The **7abc** HOTEL
OFFICE

Planning Objection
Responses

ambigram architects

Ground Floor:

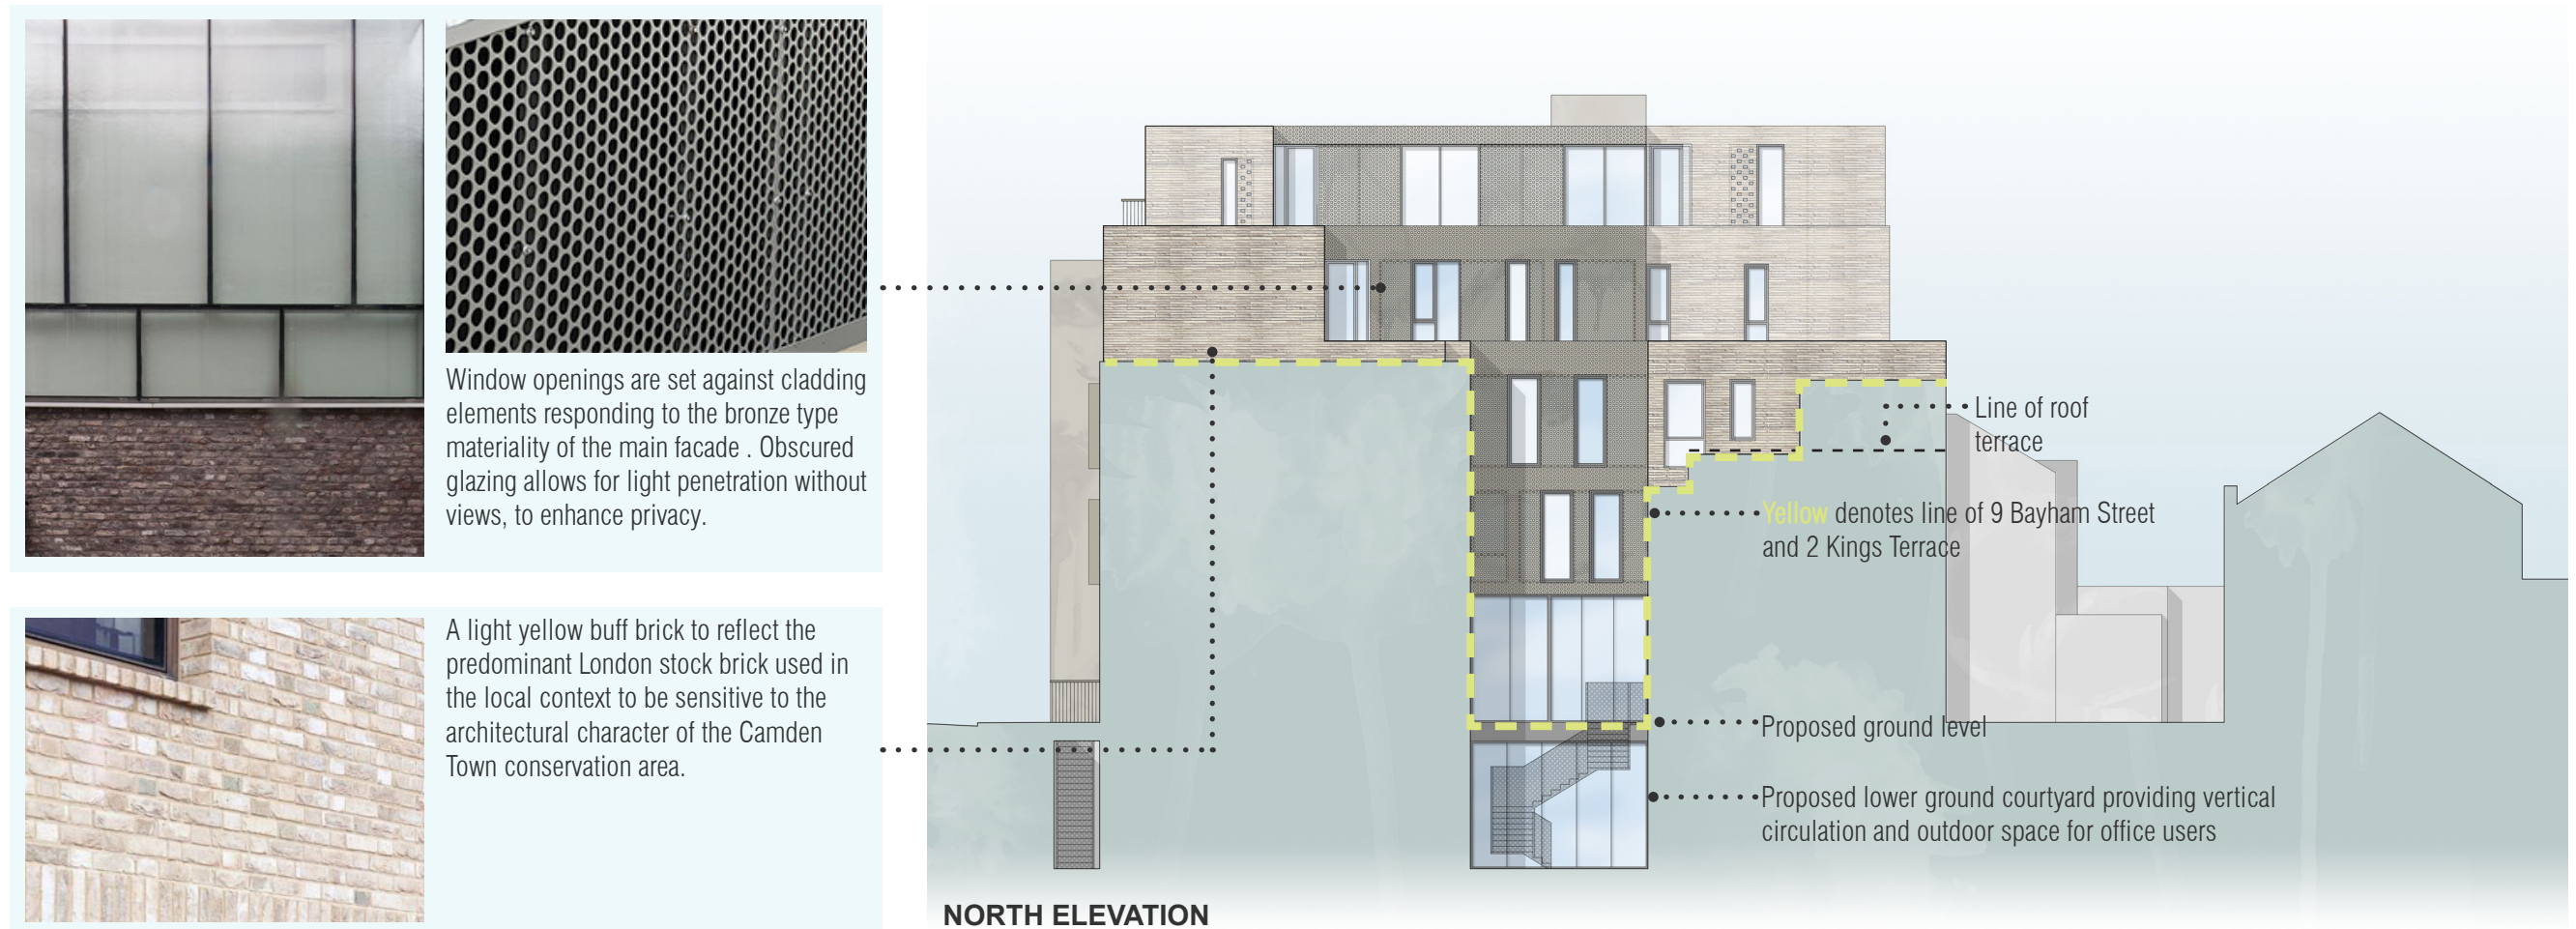
- The applicant states that the proposed courtyard is designed to bring light and ventilation deeper into the proposed development through its direct alignment with Kings Terrace, but it is not clear what the northern elevation treatment is. This is critical to understanding the potential impacts upon our amenity and quality of life.

- The facade design will be contemporary with a sensitive approach to the Camden Town conservation area.
- Fully glazed facade up to first floor to allow maximum natural light to building interior, with existing boundary wall retained to eliminate overlooking.
- Brick type to relate to existing London stock yellow.
- Large windows with translucent glazed elements to maintain privacy.
- Perforated metal cladding to allow light penetration.

Ground Floor:

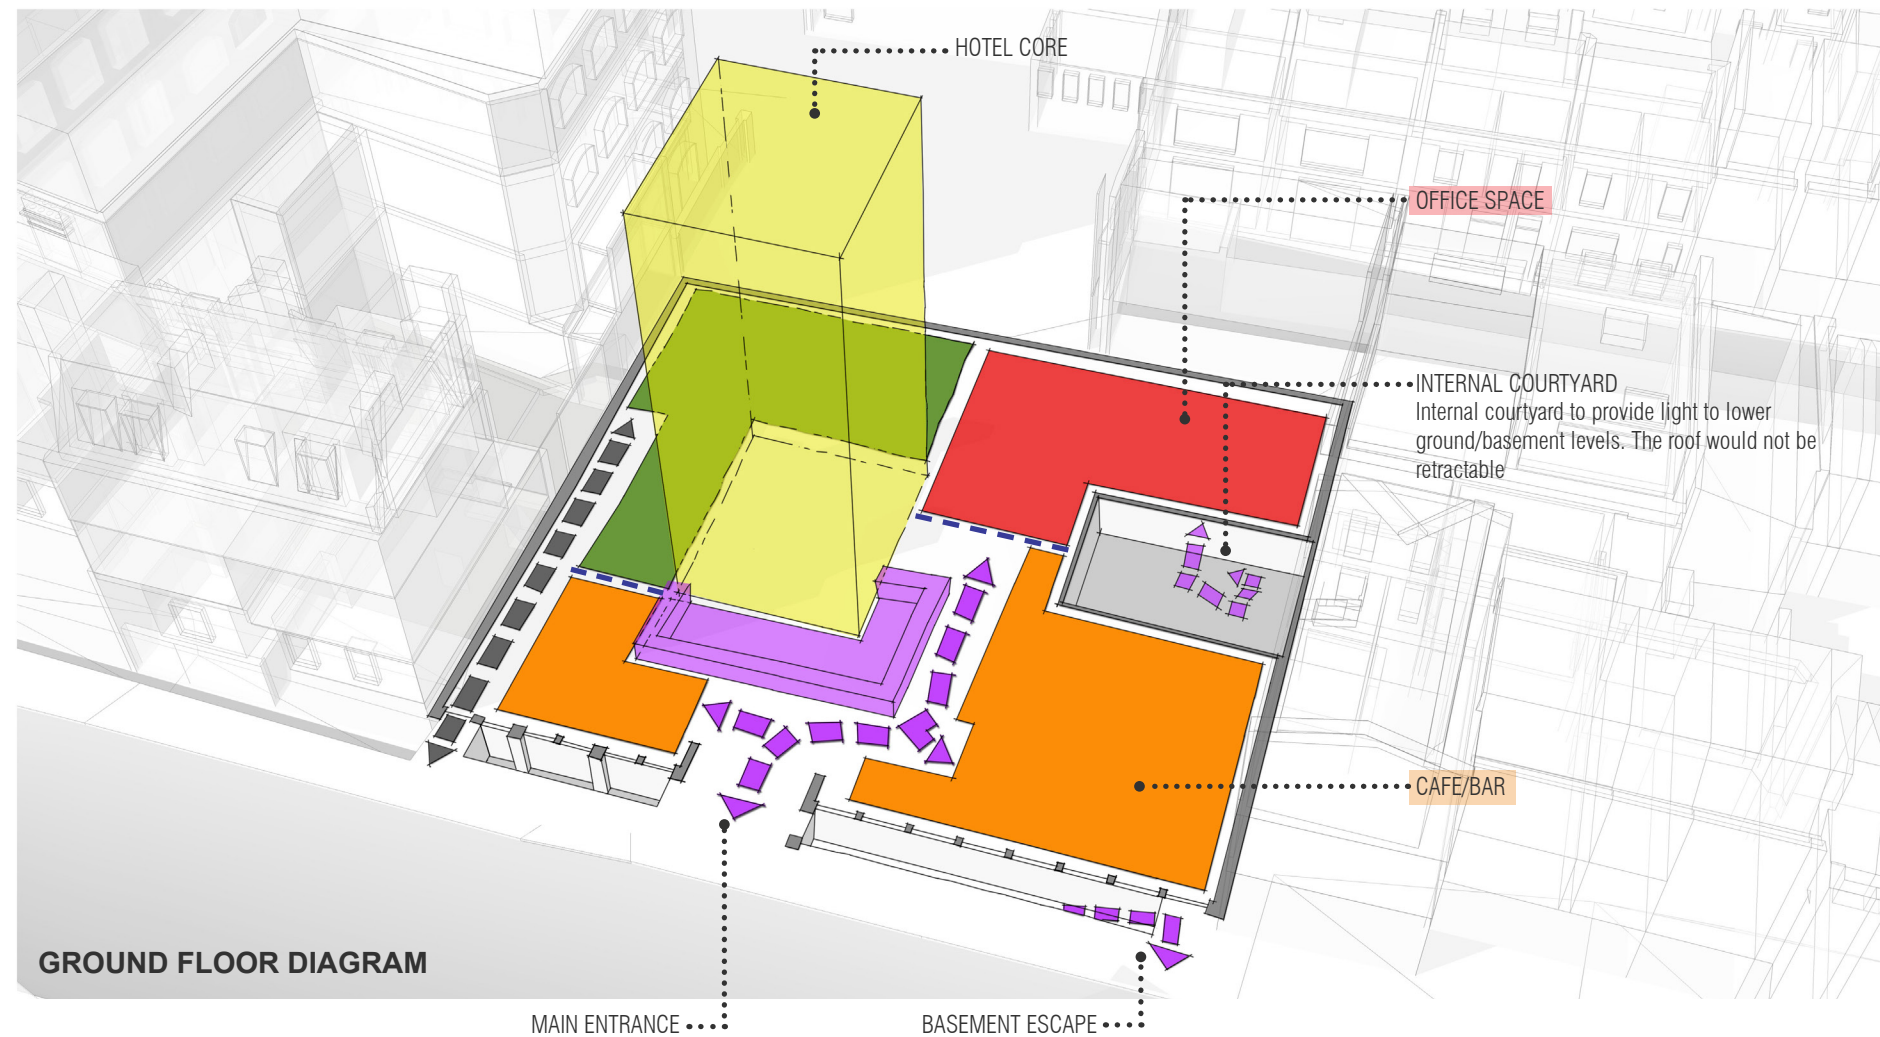
- The applicant continues by describing how the courtyard immediately adjacent to our homes would become a visual centrepiece to the publicly accessible bar and cafe. This element is to form the atrium at the core of the hotel complex, with the proposed glass roof perpetuating significant noise leakage into Kings Terrace from the publicly accessible bar and café operating immediately adjacent to this open-air element. What is most striking is that the applicant has chosen the most sensitive and least appropriate area of the building footprint to locate this proposed bar / café.

- Internal courtyard space will bring light and ventilation into lower levels
- Glazed roof to courtyard will not be retractable
- The courtyard will be located at lower ground floor level, enclosed on all sides by existing and proposed buildings.
- The courtyard will form part of the lower ground office space only.
- Cafe/Bar is internal to the building on ground floor level and accessible only from Bayham Street with no access to courtyard space. The courtyard will not form part of the bar/cafe area.
- Planning conditions can control operating hours of bar/cafe and usage types and music.

FIRST FLOOR PLAN

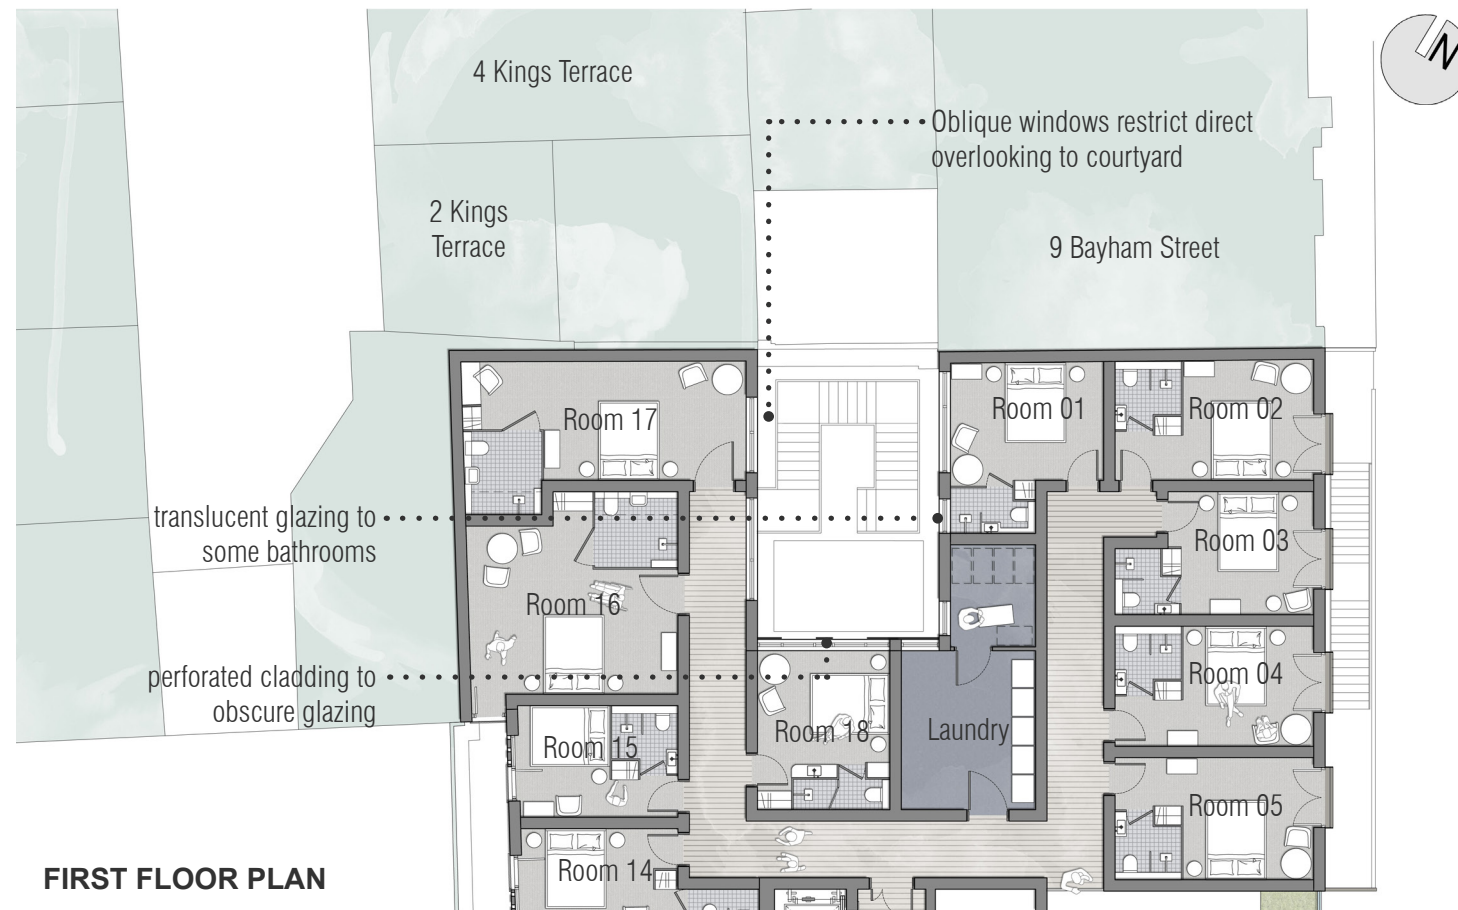
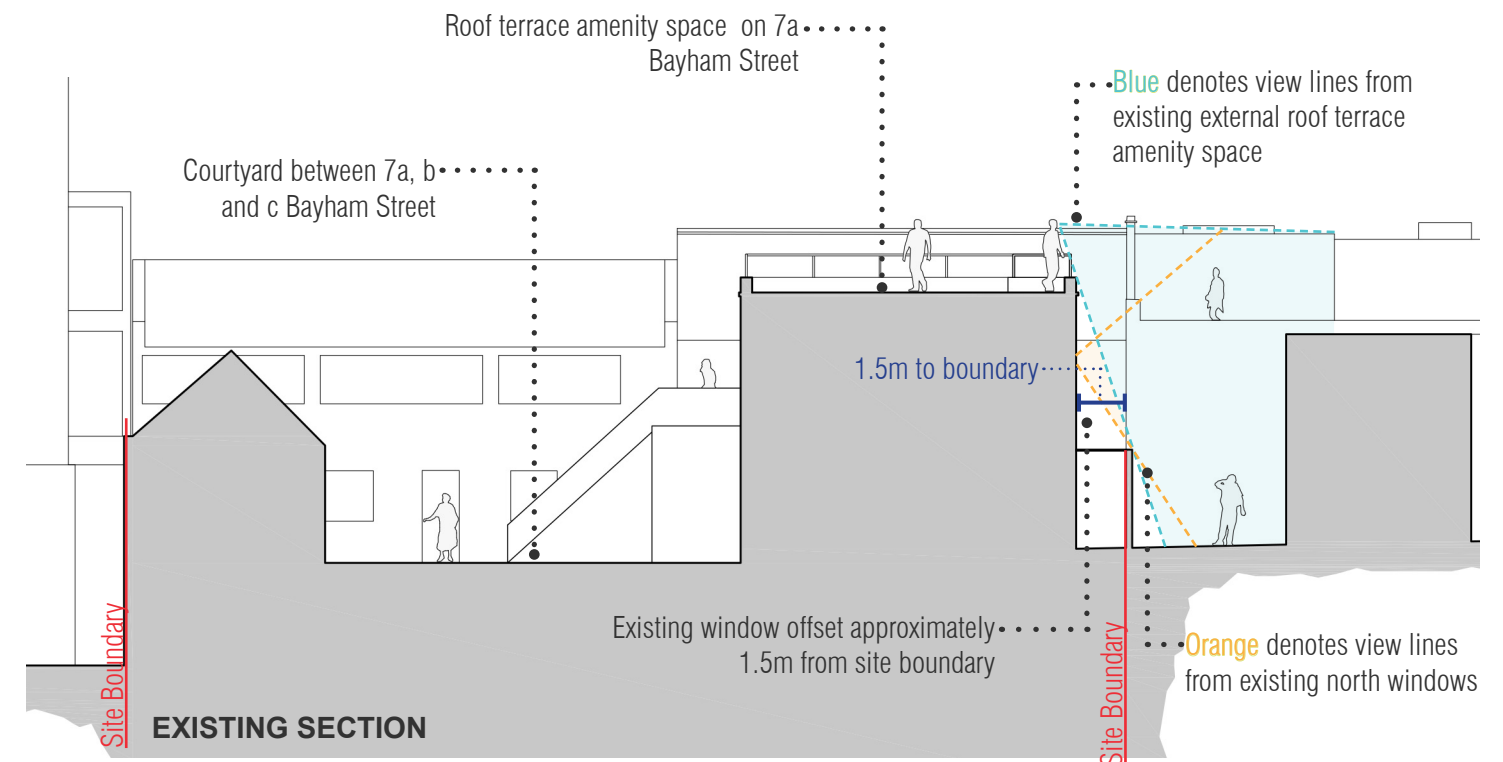
- Whilst the north elevation drawing suggests an opaque northern boundary to the courtyard at lower ground and ground floor, this treatment is glazed at first floor, which gives rise to overlooking, loss of privacy and potential artificial light impacts directly into our properties at King's Terrace.

- Direct facing glazing (room 18 and laundry) will be partly obscured by perforated cladding with cut outs to allow opening windows for ventilation. Windows to all bathrooms, will have translucent glazing to maintain privacy.
- Side facing glazing (room 17 and 01) will be oblique to rear of neighbouring courtyard, naturally restricting overlooking.
- All northern courtyard facing windows above ground level will be from hotel rooms with a maximum occupancy of two persons or low volume circulation or back of house spaces.
- Set back at a considerably greater distance than existing, increasing from approximately 1.5m to at least 8m.
- As demonstrated in the section diagrams, the proposed development reduces opportunity for direct overlooking when compared to existing.

First Floor:

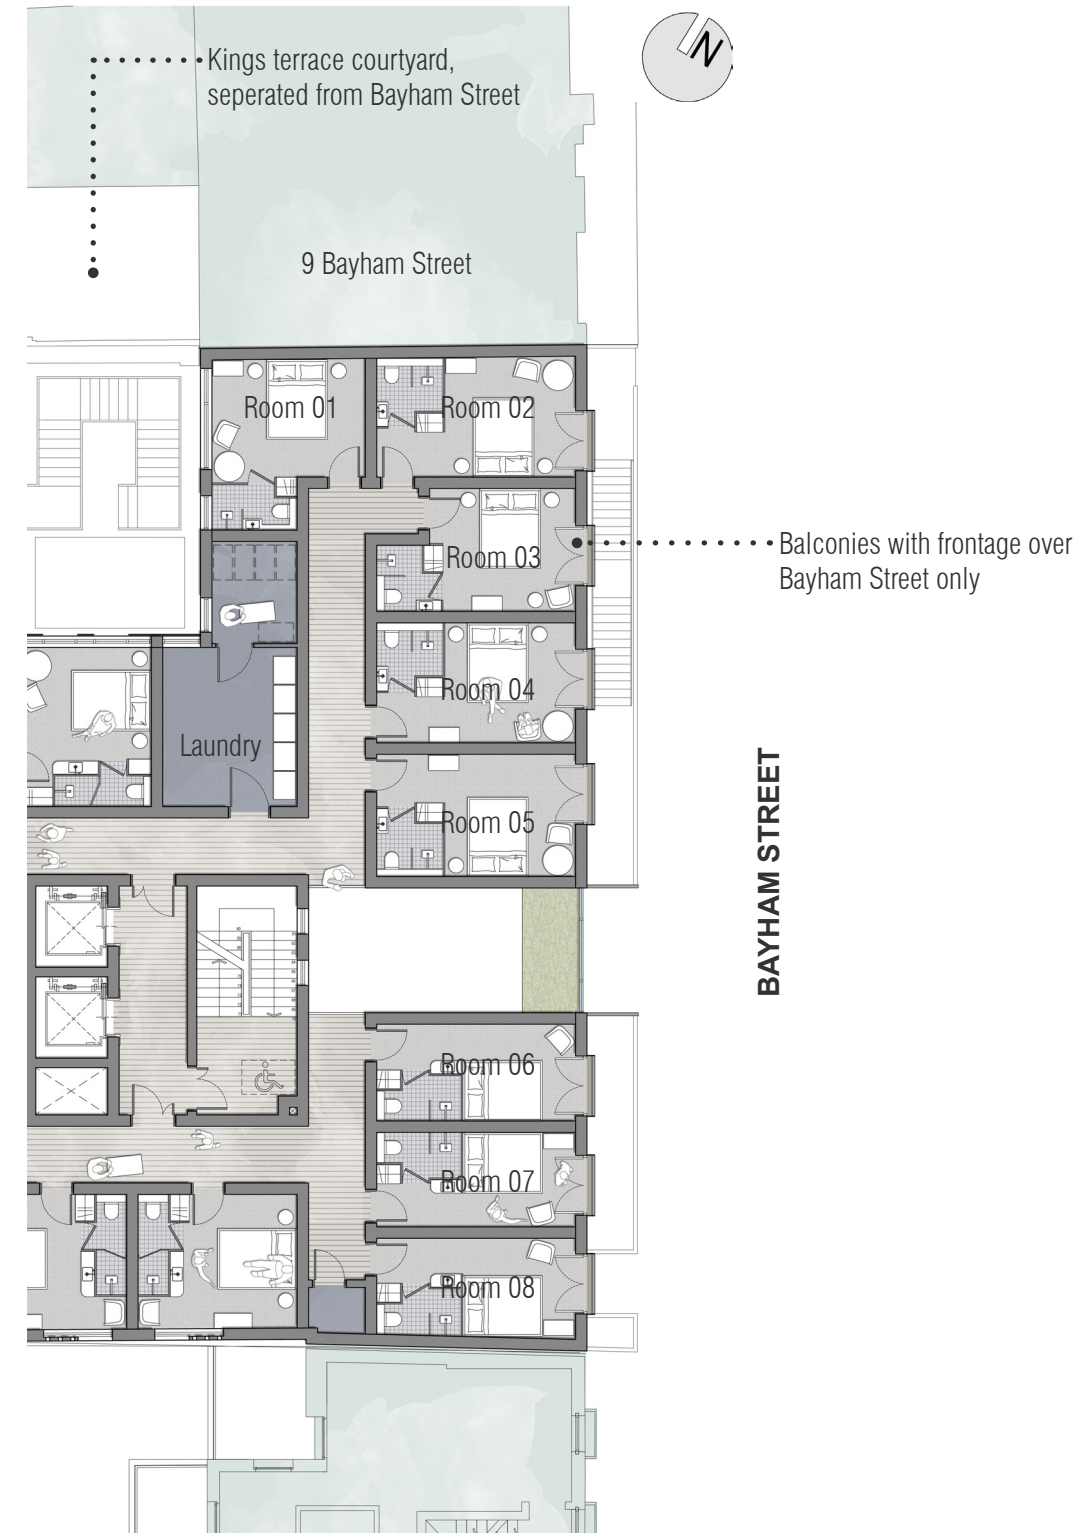
- The submitted Design and Access Statement indicates opportunities to create balconies over Bayham Street with projecting oriel windows, which would give rise to noise and disturbance from use by hotel guests - with hotels comprising a 24-hour material operation.

- All hotel rooms with aspect over Bayham Street have been designed to mitigate existing street noise with high quality acoustic glazing for the comfort of hotel guests.
- Juliet balconies enclosed within oriel windows are shown to only a small number of rooms on the Bayham Street facade only.
- It is unlikely any noise produced from hotel rooms with juliet balconies would be greater than that already produced from other residential or commercial premises already on Bayham Street or the existing levels of traffic noise.
